Oakwood-Lincoln Park Response to Staff Memorandum for Appeal, Item # 62. MPC file # 12-B-17-OB

Re: 10-B-17-IH
431 E. Springdale Ave

RE: 10-B-17-IH
431 East Springdale Ave

Above: 317 East Springdale

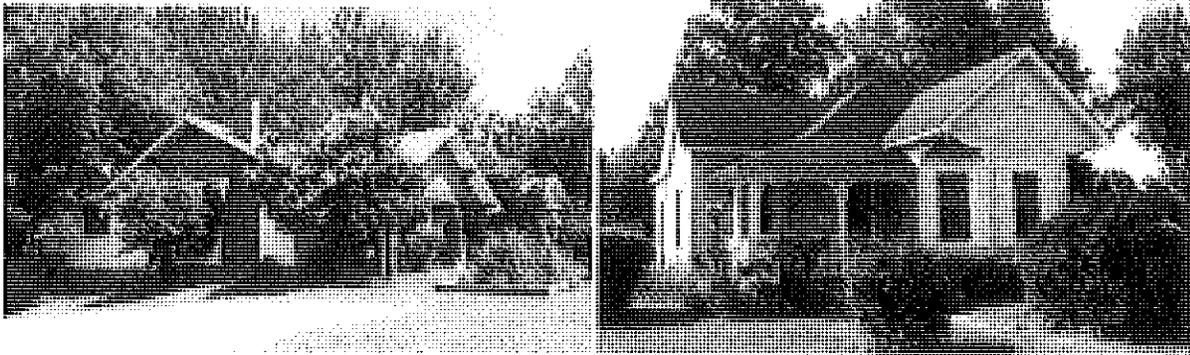
The developer previously announced that it was using 317 East Springdale Avenue, a Craftsman-style house, as a model for the current proposal, but their design fails to match that property, at least with regard to the wall height and roof style. When that discrepancy was pointed out, the developer offered to raise the wall height to at least 9 feet, and told City Council in September 2017 that they would do so. Interestingly, their current proposal shows a *lesser* wall height.

425 East Springdale (Craftsman) below

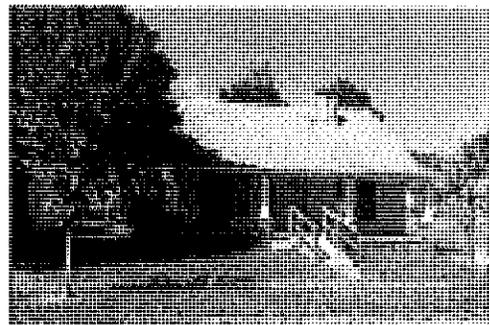
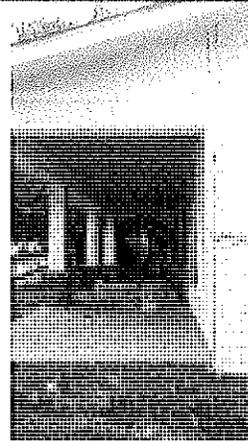
This is the house next door, built at a later time than original house at 431 East Springdale.

If a Craftsman style house is to be referred to, it should be on the block, not a block that was developed later.

This house is 35 feet wide and 52 feet deep.

The Exterior Wall Height is approximately 9 feet, 10 inches.
